REMARKS

Claims 1-19 are pending in this application. In the July 14, 2005 Office action, the Examiner (i) objected to the drawings for various informalities, (ii) objected to the specification for various informalities, (iii) objected to claim 1 because of an informality, and (iv) allowed claims 2-11.

Fig. 2

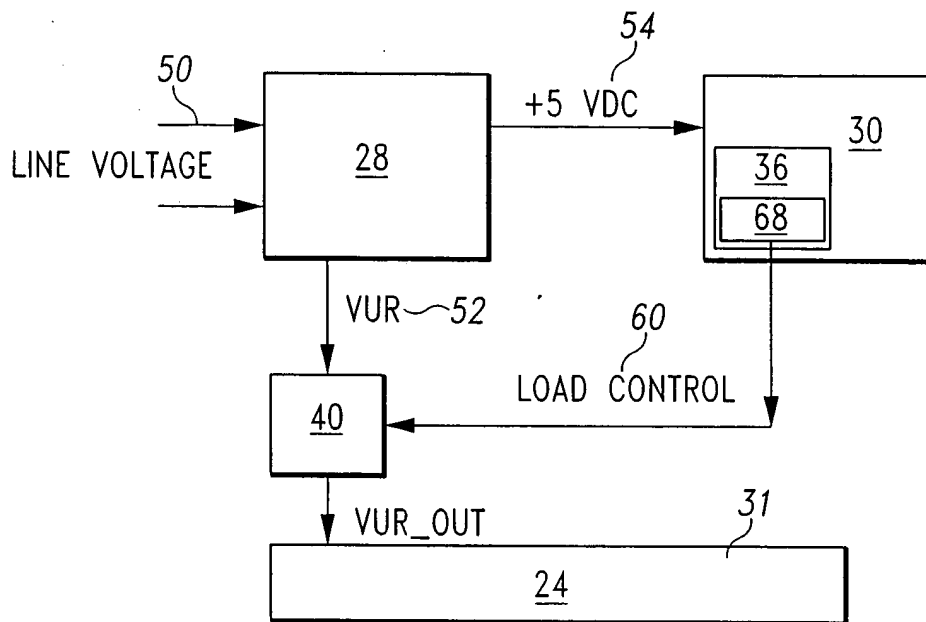
Third, in the July 14, 2005 Office action, the Examiner stated that Fig. 2 "is not fully described in the detail description of the drawings." Applicant notes that Fig. 2 is described on page 7, lines 18-20 of the section entitled, "Brief Description of the Drawings". In addition, pursuant to the above amendments, Fig. 2 is now referenced in the paragraph starting on page 8, line 13.

Fig. 6

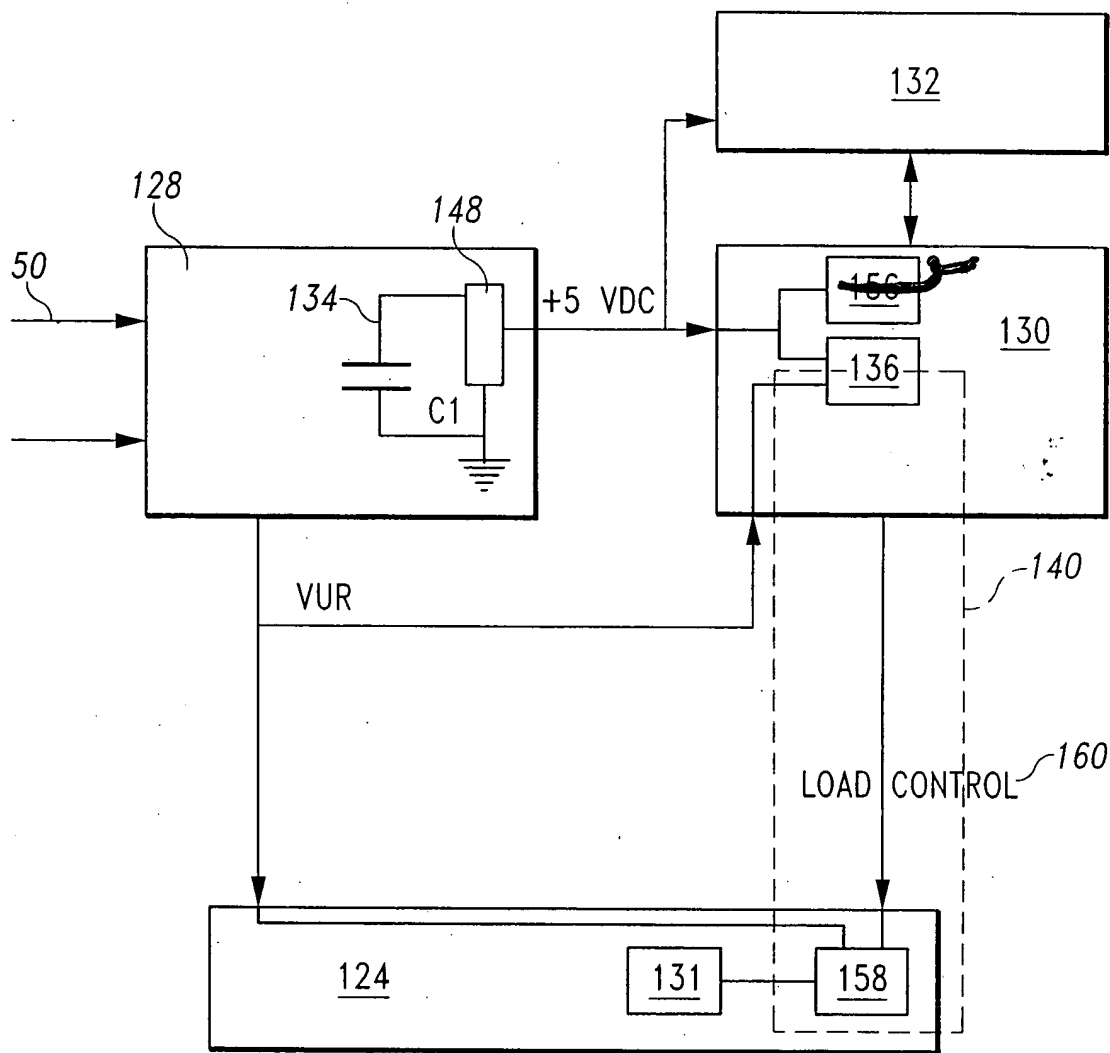
First, in the July 14, 2005 Office action, the Examiner stated that reference numeral 148 mentioned in the description was missing in the drawings. Applicant respectfully notes that reference numeral 148 is already shown in Fig. 6. Accordingly, no amendments have been made concerning reference numeral 148.
